PLANNING BOARD AGENDA
OCTOBER 13, 2022 – 7:00 P.M.

**Re: Liberty New York Water
Wellhead Treatment at West Branch Acres
H2M Project No.: NYAW2105**

RE: Site Plan P&R Estate Corp.
44.13-2-68

RE: Jedlicka 2 Lot Subdivision
334 Austin Road
TM#: 64.13-1-16

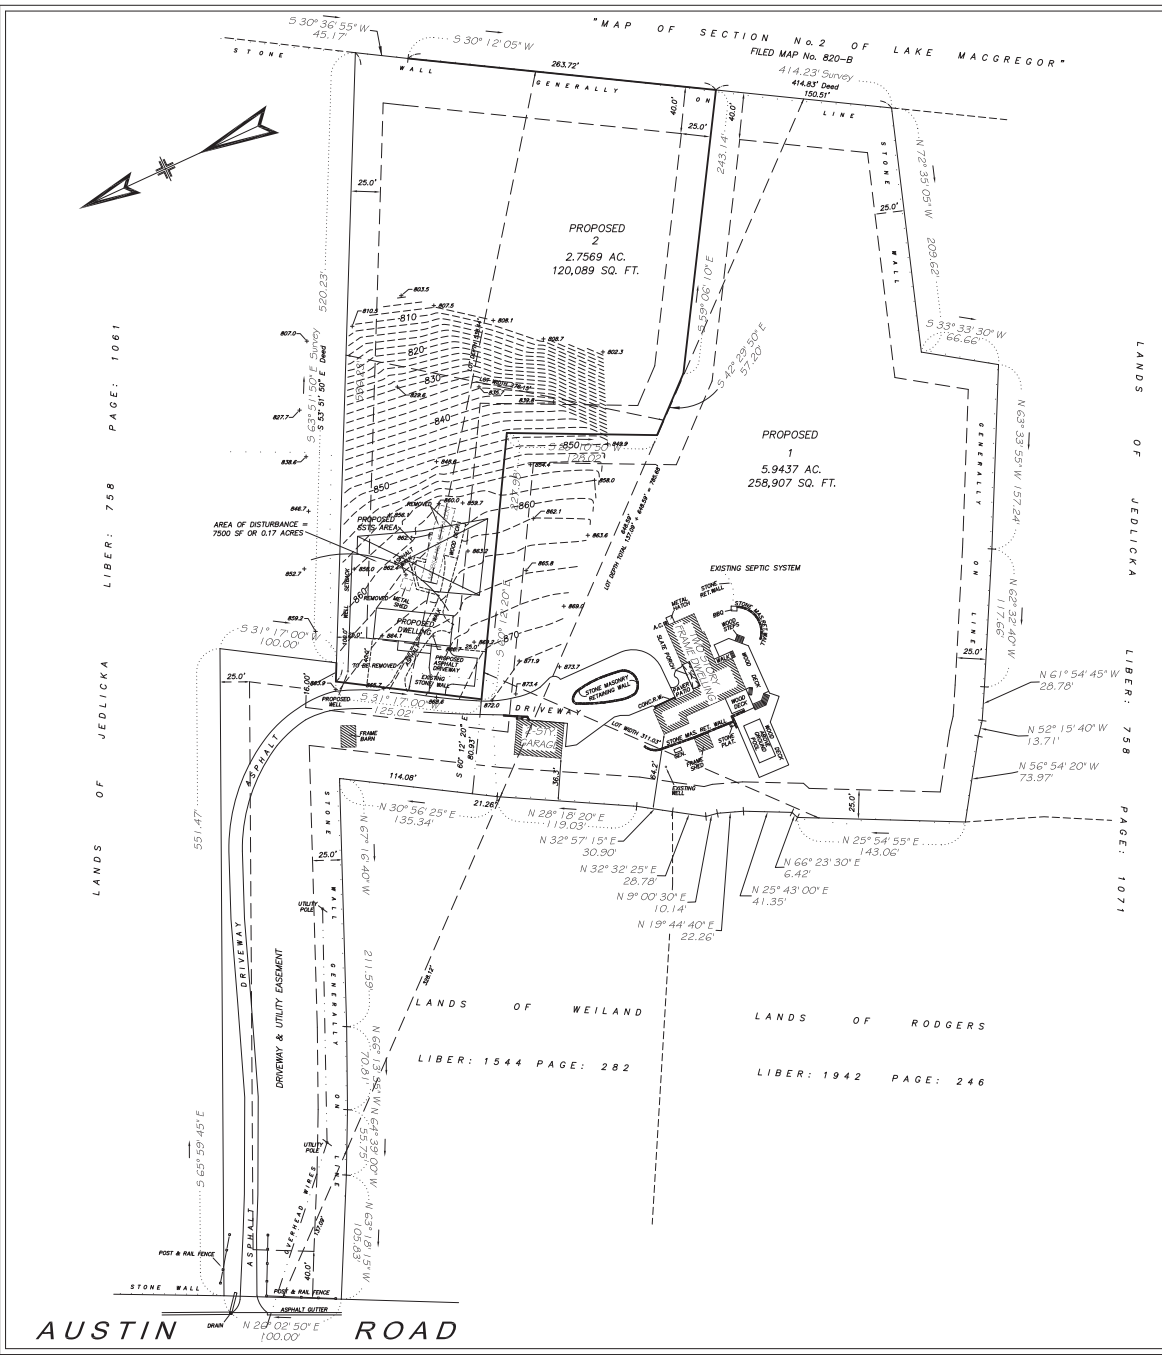
The following is my response to Mr. Franzetti's memo of September 21:

1. The Subdivision Plat was already submitted with the initial application.

2. The subdivision plat and Site Plan clearly show that Lot #2 does not have any road frontage.
3. Driveway easements and maintenance agreement have been submitted for the Planning Board Attorney's review.

4. The topography has been added for Lot #2
5. A note has been added regarding the existing stone walls.
6. No area for open space is being proposed.
7. ***The next six items on Mr. Franzetti's memo (items a-f) apparently do not pertain to this project since these items refer to a project at 419 Union Valley Road, Tax Map #88.7-1-22.***

SKETCH PLAT
 PREPARED FOR
REGINA JEDLIČKA
 SITUATE IN THE
TOWN OF CARMEL
 PUTNAM COUNTY
 NEW YORK

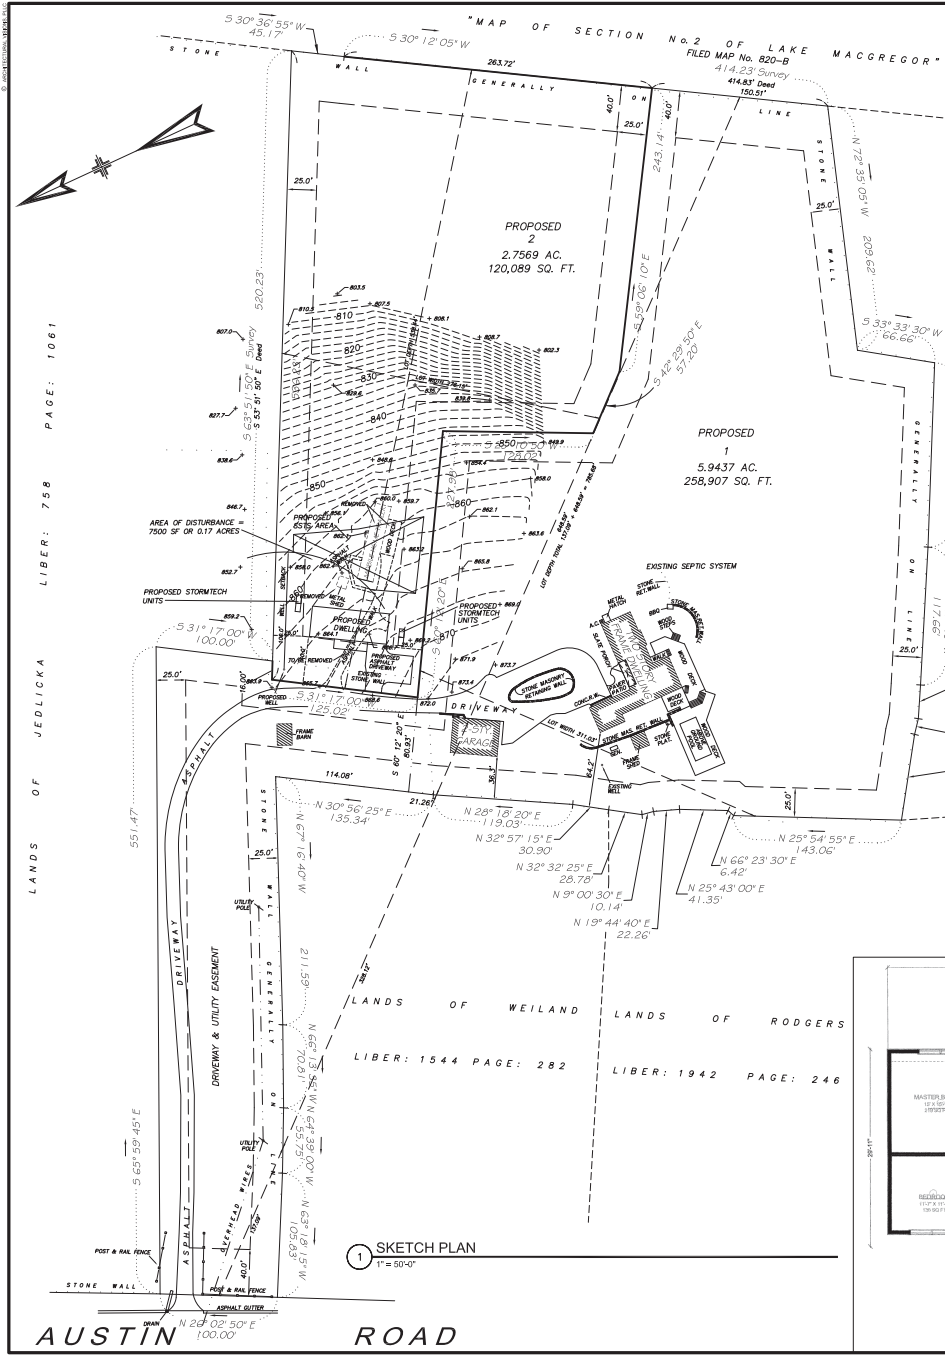
The following is my response to Mr. Cleary's report of September 28:

1. Open Development from the Town Board has been noted on the Site Plan.
2. It is my understanding that the lot width requirement for Lot 1 is met.
3. The proposed access easement has been referred to Mr. Charbonneau, the Planning Board Attorney.

4. There are no existing changes to the curb cut on Austin Road.
5. A well and septic permit will be obtained from the Putnam County Department of Health. The testing has been completed and approved by the Health Department.

6. The topography for Lot #2 has been added.
7. The stormwater management plan will be submitted after Town Board and Zoning Board approval has been obtained.
